Owner Change Order

Change Order Number: 003

City of Norman - North Base Complex Phase 1
1310-1380 DA Vinci Street
Norman, Oklahoma 73069

The Contract is hereby revised by the following items:

1 ROOF HYDRANT DETAIL

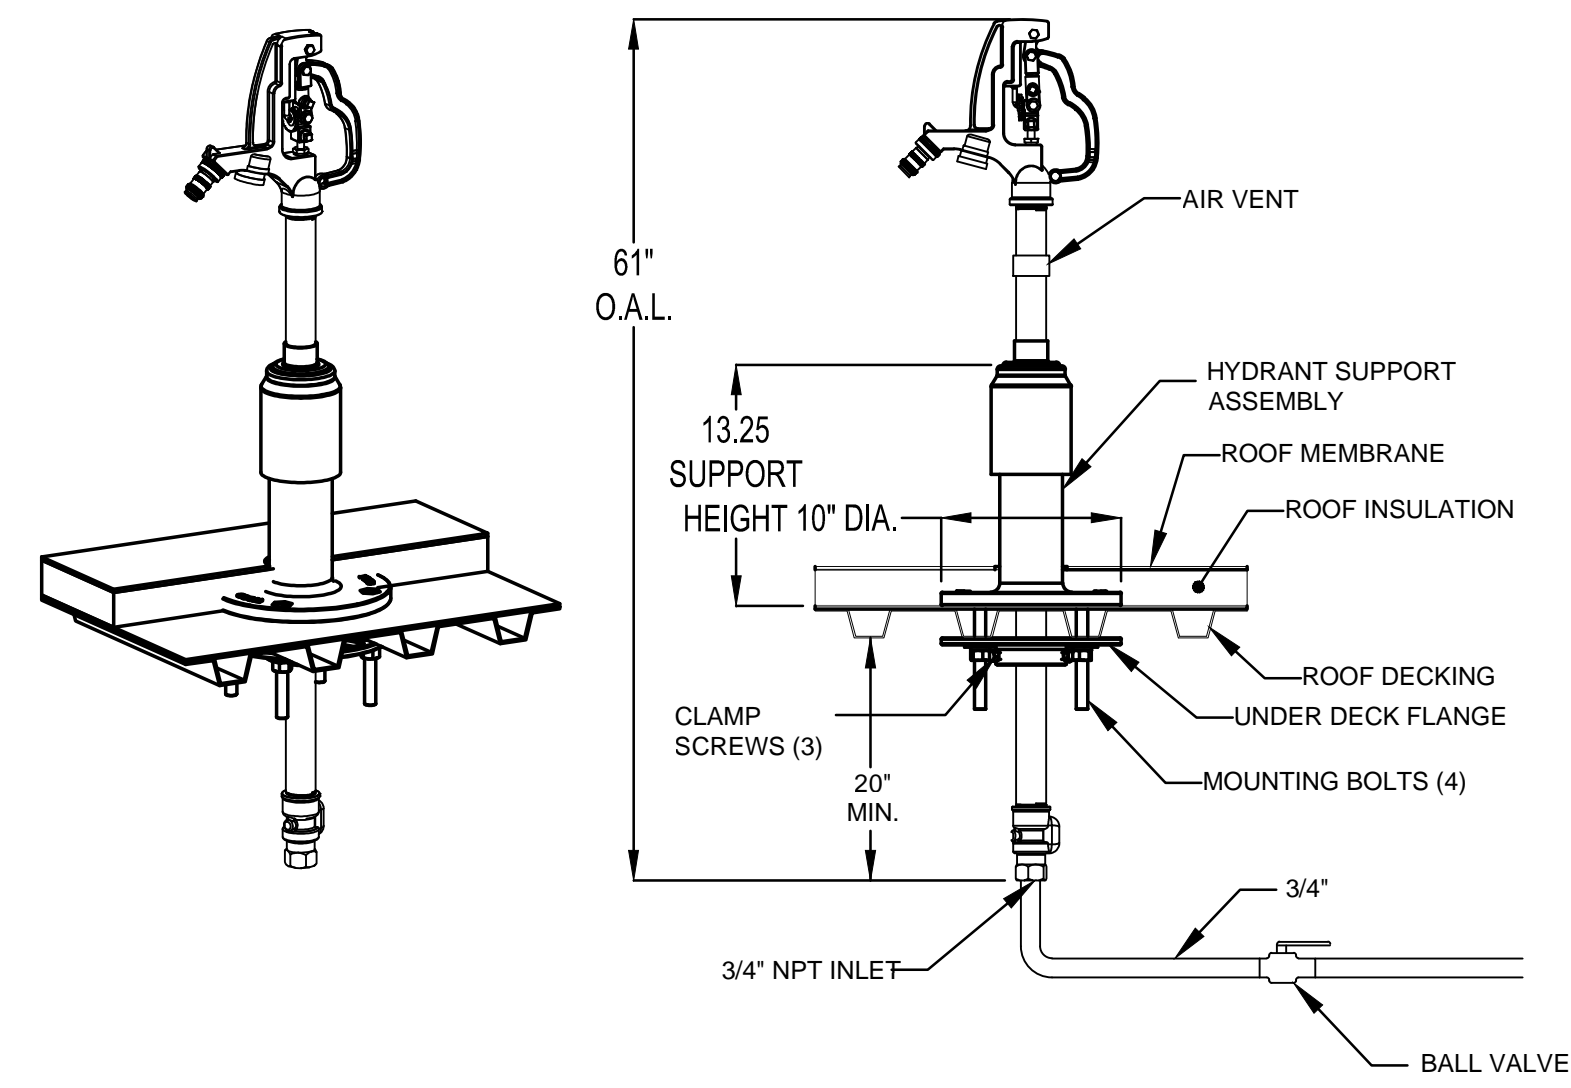
Reference attached SK1 which includes the roof hydrant product data and the plumbing fixture schedule from sheet M5-02 P6A Roof Hydrant - The plumbing fixture schedule on sheet M5-02 notes for the roof hydrant to be mounted as indicated on detail, however no detail has been provided. The hydrant that is specified and submitted and approved is made for a roof with a slope less than 2 degrees, which our roof exceeds.
Flintco proposes to make a curb for each hydrant (6 total). The curb would essentially be a false curb that creates a flat surface to mount the hydrant.
1) Please provide a detail if the curb option is acceptable, including finish requirements.
Attachments:
[RFI #054-SK1.pdf](#)

Proposed solution is acceptable. Detail 1 is for the roof hydrant. Detail 2 is for the roof curb, with a hydrant as the piece of equipment to be installed on the curb.

1 ROOF HYDRANT DETAIL

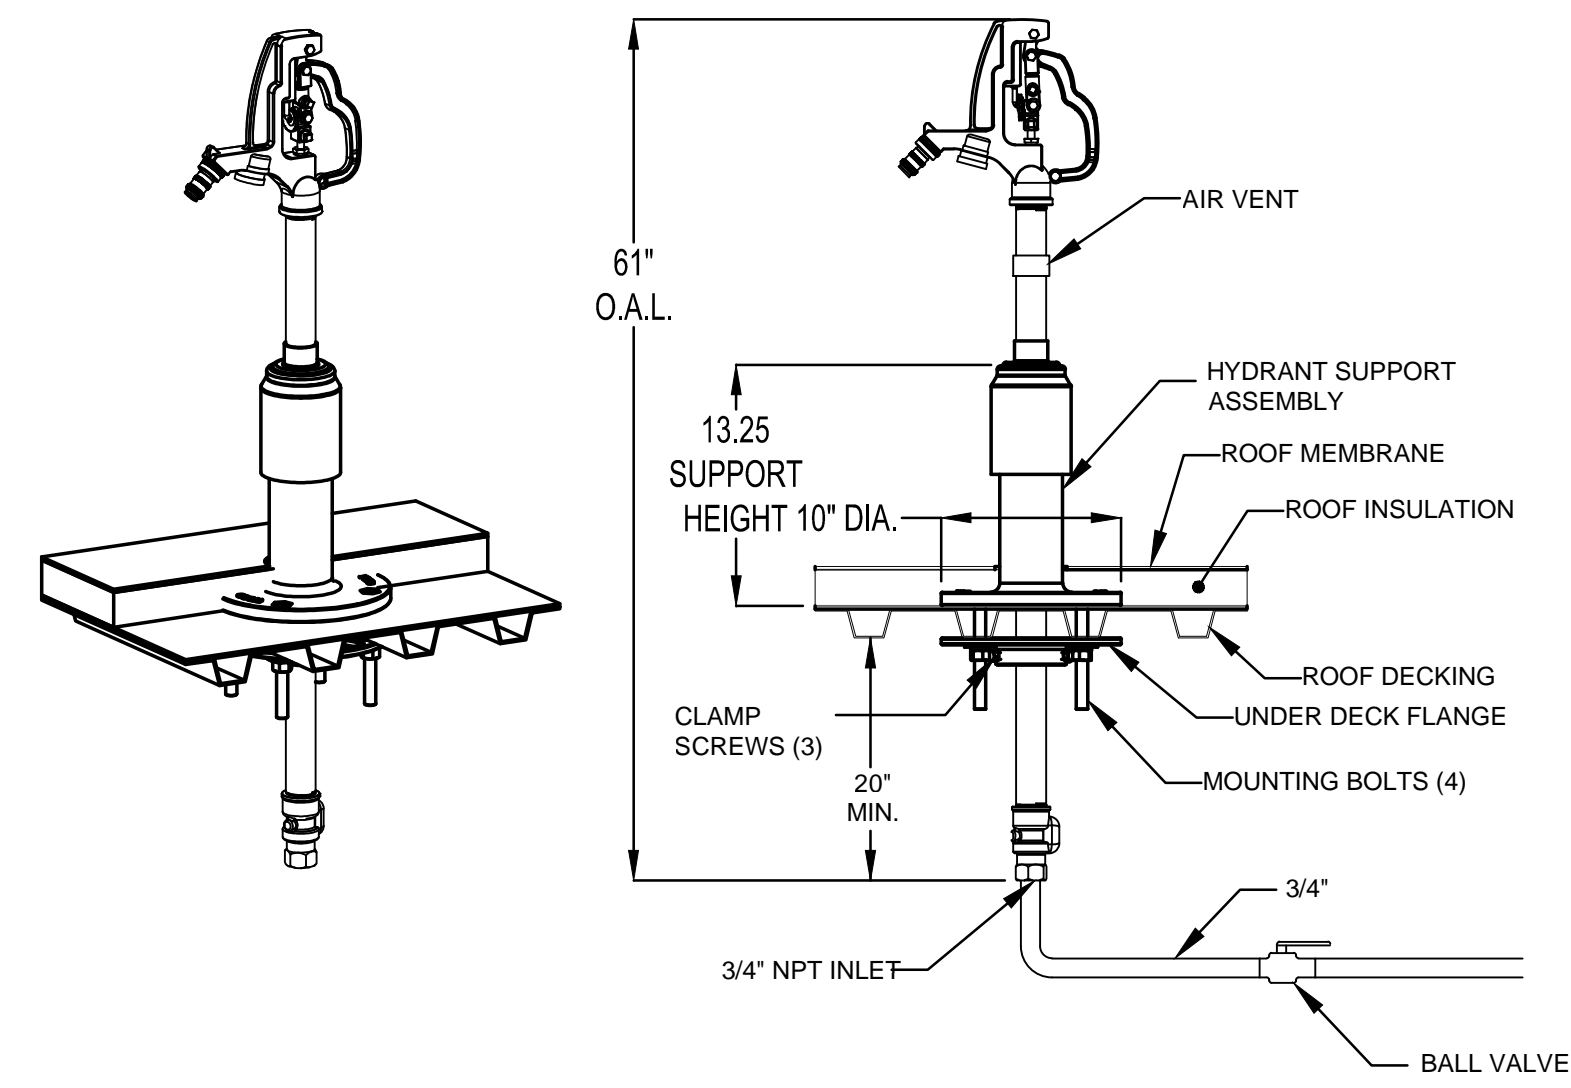
Reference attached SK1 which includes the roof hydrant product data and the plumbing fixture schedule from sheet M5-02 P6A Roof Hydrant - The plumbing fixture schedule on sheet M5-02 notes for the roof hydrant to be mounted as indicated on detail, however no detail has been provided. The hydrant that is specified and submitted and approved is made for a roof with a slope less than 2 degrees, which our roof exceeds.
Flintco proposes to make a curb for each hydrant (6 total). The curb would essentially be a false curb that creates a flat surface to mount the hydrant.
1) Please provide a detail if the curb option is acceptable, including finish requirements.
Attachments:
[RFI #054-SK1.pdf](#)

Proposed solution is acceptable. Detail 1 is for the roof hydrant. Detail 2 is for the roof curb, with a hydrant as the piece of equipment to be installed on the curb.
